CITY OF EL MIRAGE DEVELOPMENT APPLICATION FORM

Case No: PZ22-12-33 Date Received: 12/12/2022 PC Meeting: 1/24/2023 CC Meeting: 2/22/2023

TO: Alex Hayes, Withey Morris, PLC
FROM: Jose A. Macias, Senior Planner
 Development Services Department, Planning & Zoning
RE: PZ22-09-26 Agua Fria Commerce Site Plan Approval
DATE: January 24, 2023

TO: Jose Macias, Planner/GIS
FROM: Bryce Christo, P.E., Assistant City Engineer
SUBJECT: Agua Fria River RV, Boat & Storage – Development Application Review
DATE: 01-17-23

SITE PLAN FOR CACTUS & AGUA FRIA RV, BOAT & STORAGE CAMPUS

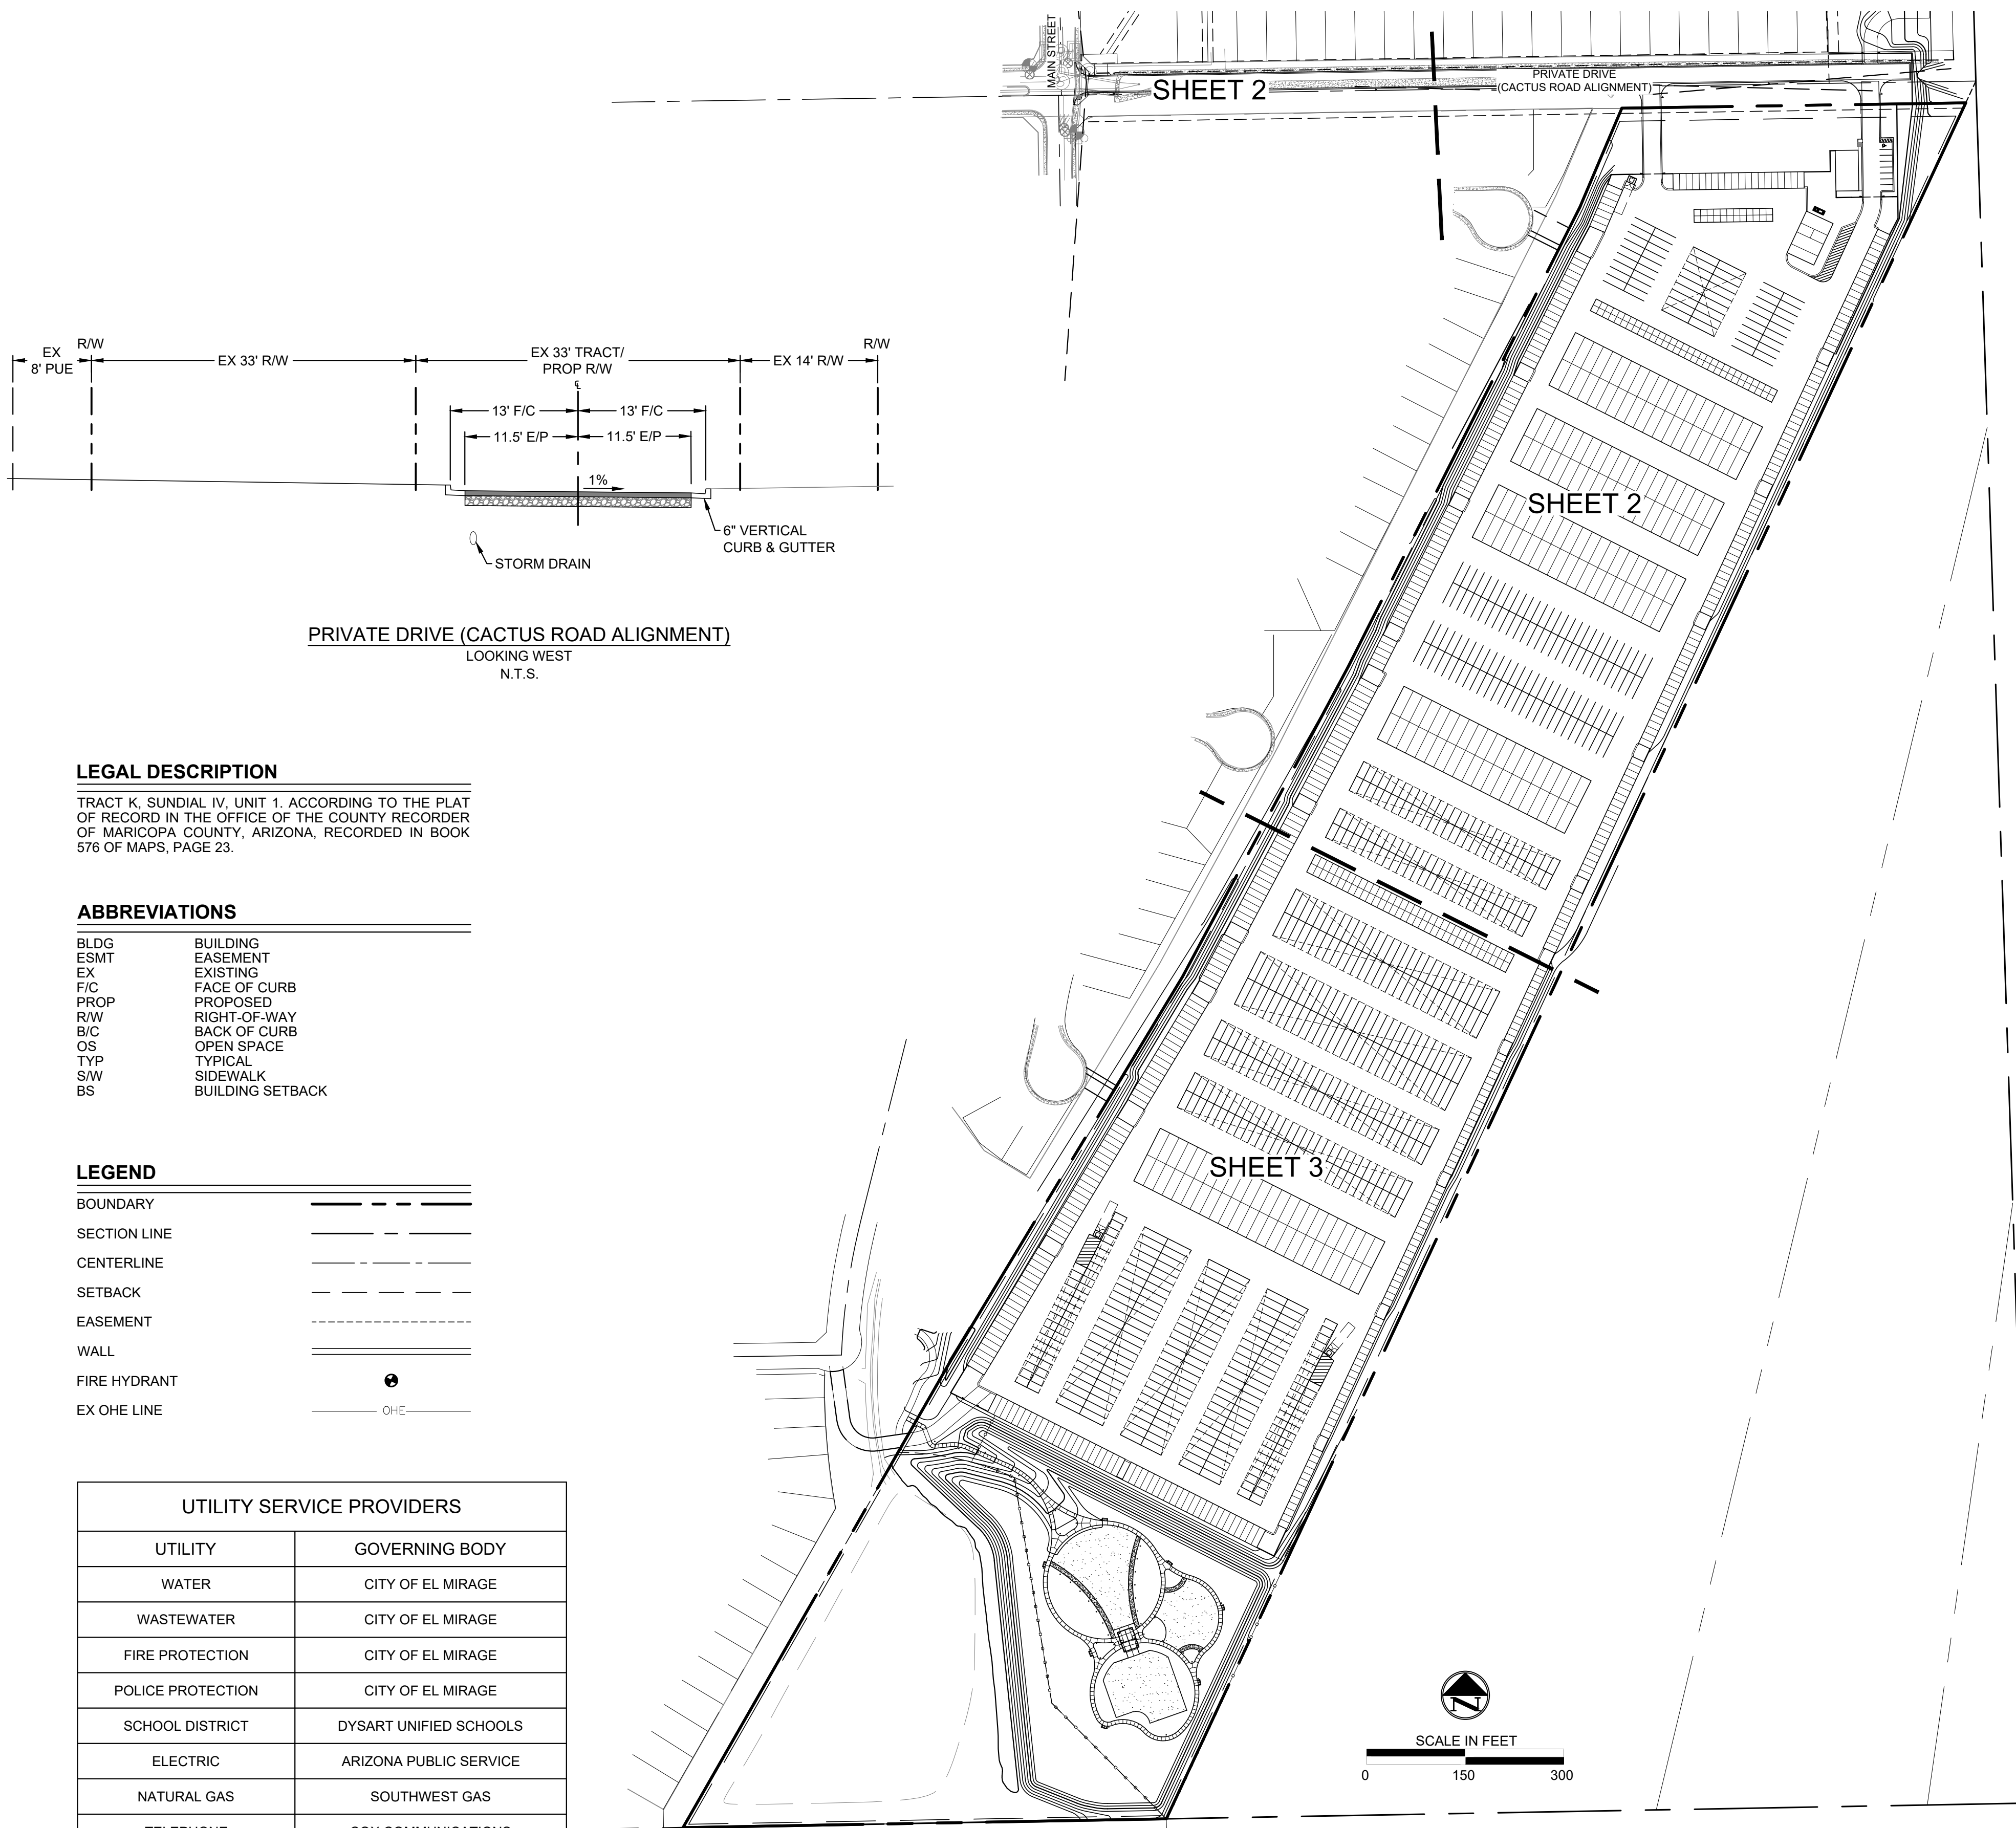
2. The driveways shall be per MAG or City details. Stop signs are recommended at each driveway. Verify all driveways have a minimum throat of 50 feet. Parking spaces are not allowed within this 50 feet. **Stop signs added where applicable. 50 min. met.**

4. Add the Site Distance Easement per City Detail EM-158 to all driveways and applicable legs of the Cactus Road and Main Street intersection. **Added**

6. The extension of Cactus Road will be a private roadway and the following shall apply:
 - a. The roadway shall consist of two lanes, each 13 feet wide measured from centerline to face of curb. Roadway is 26' from face to face

- b. The sidewalk can be removed. Removed
 - c. The roadway shall be shifted to be completely within the 33 foot private parcel (APN 501-36-006J). Roadway has shifted to the center of 33' parcel

- d. An automatic gate with emitters shall be installed approximately 100 feet east of the Main Street eastern curb line. Gate not added as it is a safety concern as no turn around could be provided prior to the gate. This would force traffic to back up into traffic at the intersection of Cactus Road and Main Street.

- e. A similar, second gate needs to be installed at the eastern end of the road to allow access to the river bottom. The gate and a wall must extend the full 80 feet of the tracts. A wall shall also be extended along the north side of the tract, from the proposed gate to the end of the existing Arizona Brisas wall. Wall and gate provided

- f. A turnaround is required at the eastern end of the road per City Detail EM-114. Hammerhead Provided
 - g. "No Parking – Fire Lane" signs are required along both sides of the roadway. Signs added every 200'
Spacing and sign details shall be determined by the Fire Department.

CHECKED BY:	DMS
DRAWN BY:	CRS
TITLE:	COVER SHEET
SHEET No.	1 of 3
PROJECT No.	1410

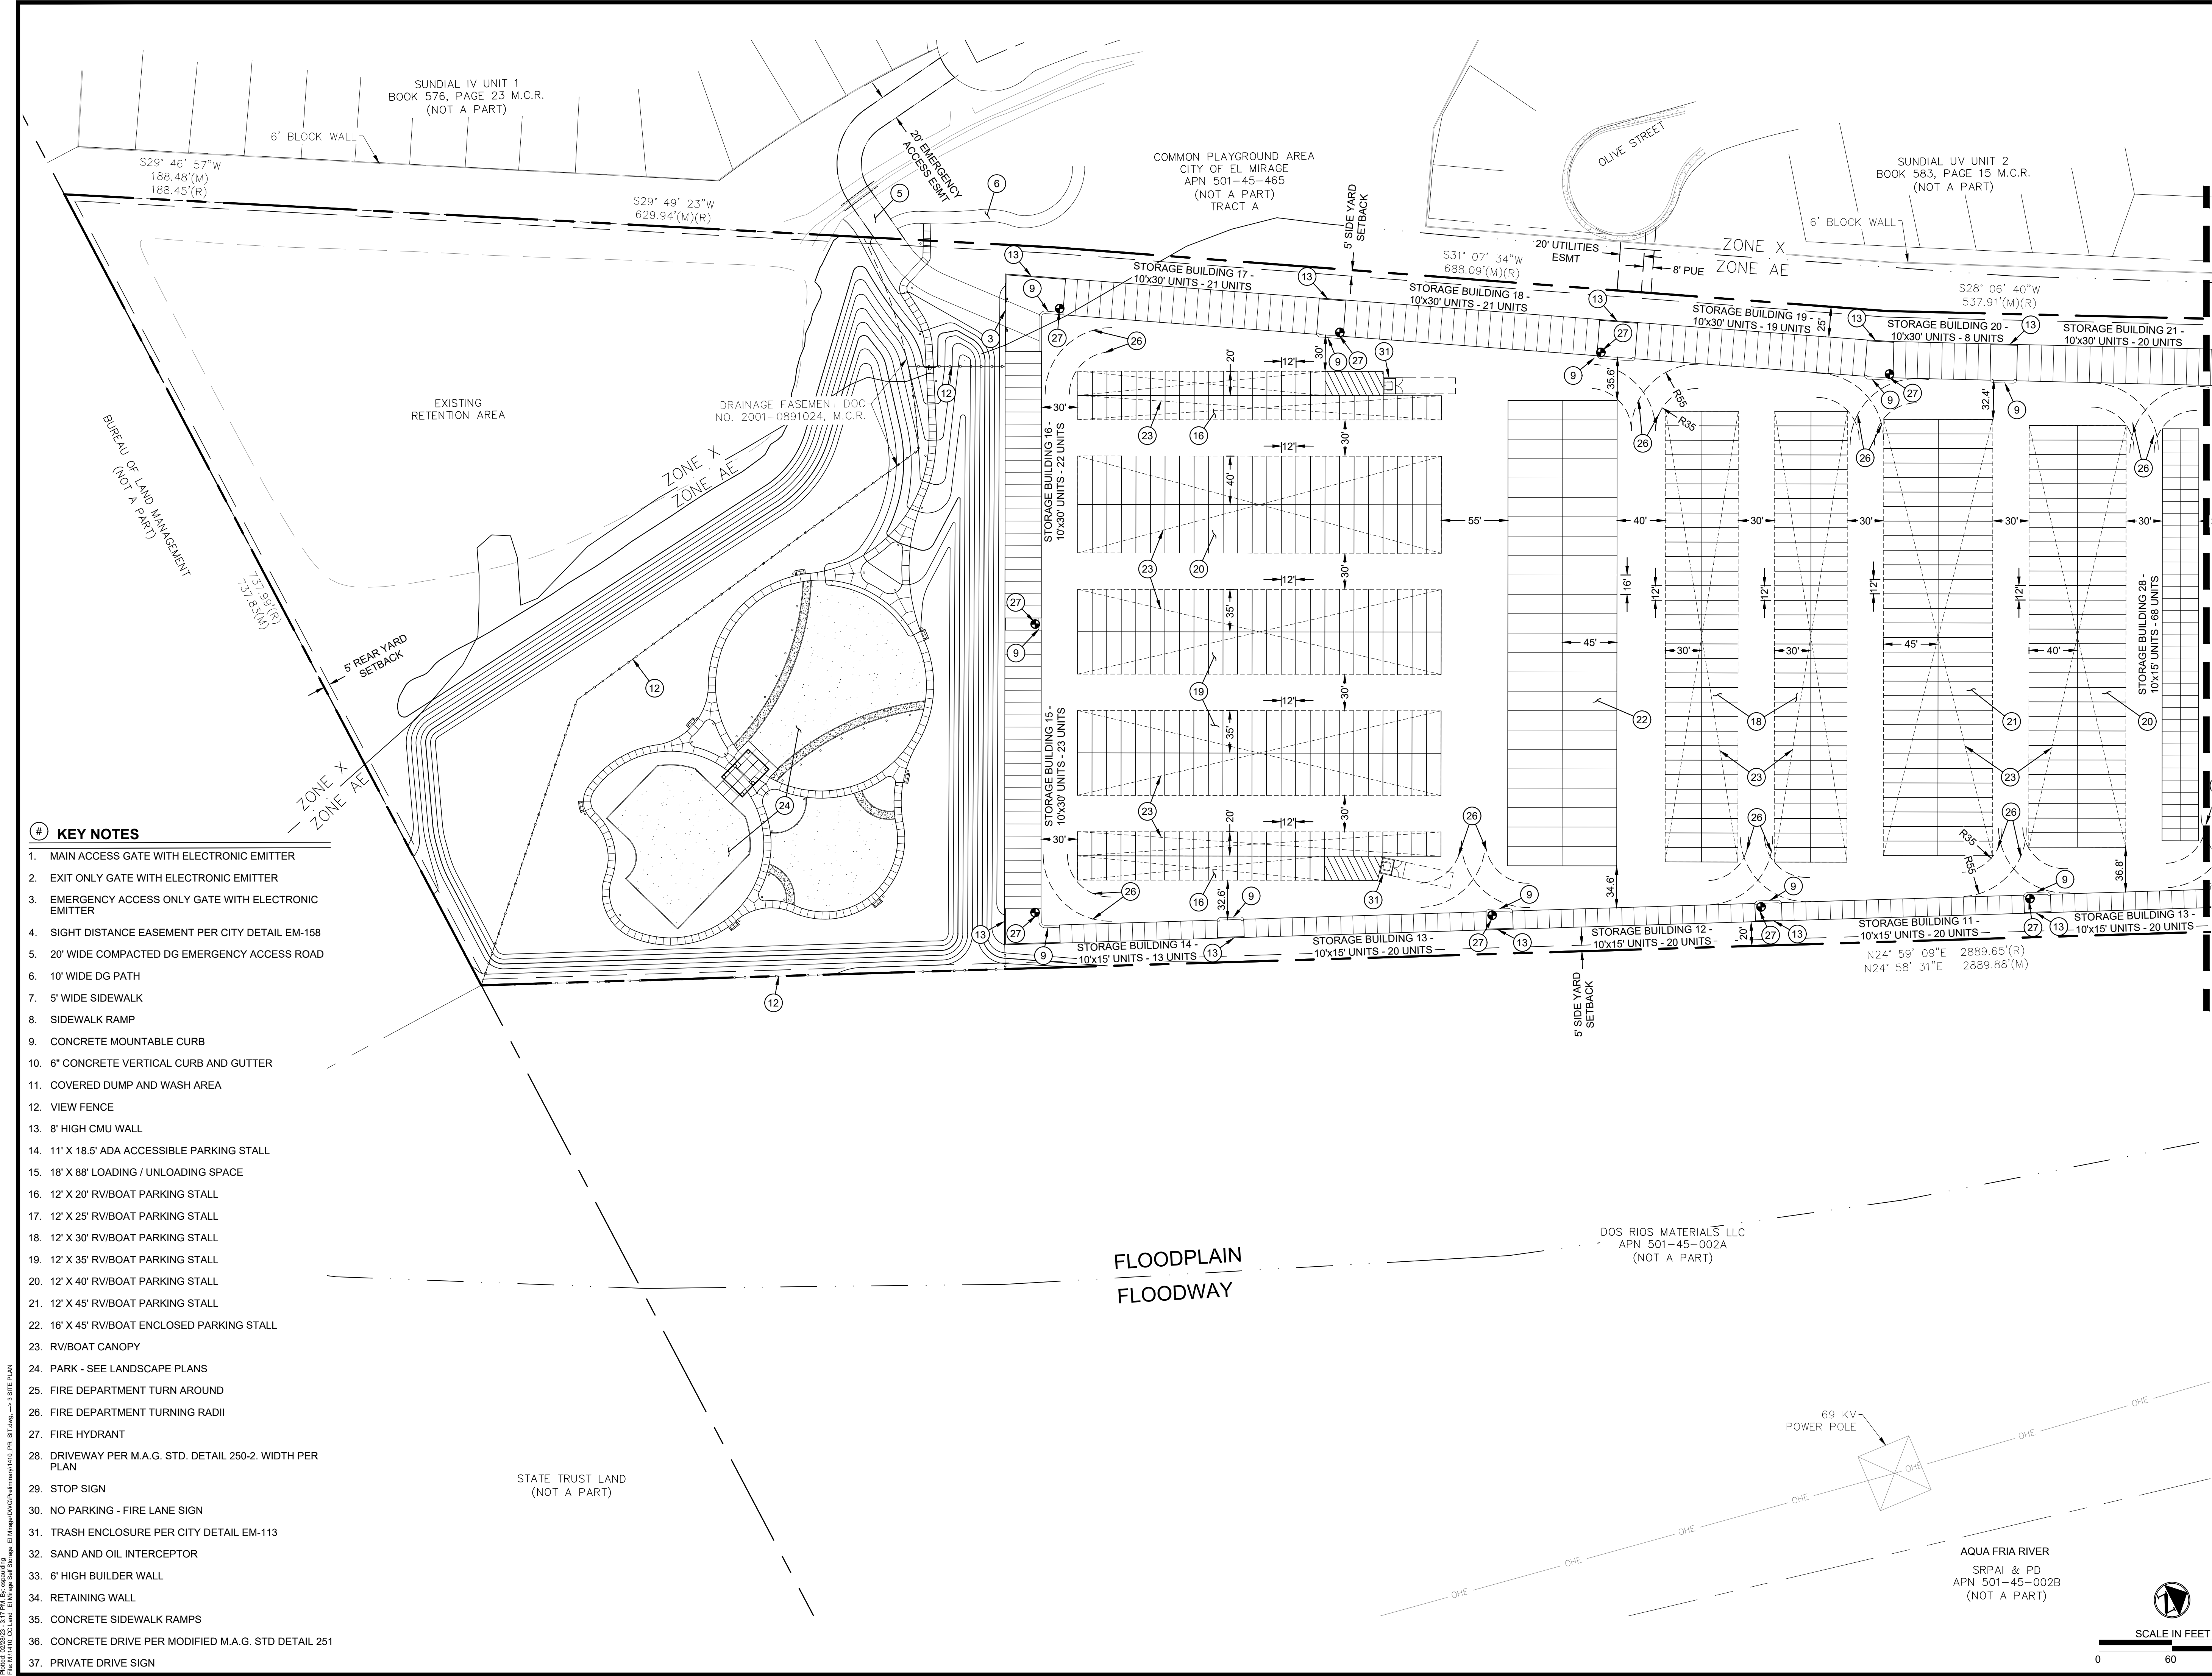
1. Cover Sheet
 - a. Development Standards
 - i. The Provided Wall Height is noted as 8 feet tall but the Wall Plans and Details show 6 feet. Which is correct? **Wall height to be 8' as shown on revised plans**

- iv. Parking stalls shall be a minimum of 9’ x 18’. **Stalls are 9'x18'**
 - b. Coordinate System – The GDACS Point should be 30782-Z1.
 - c. Notes Section – What does Section 1112 in Note 6 refer to?
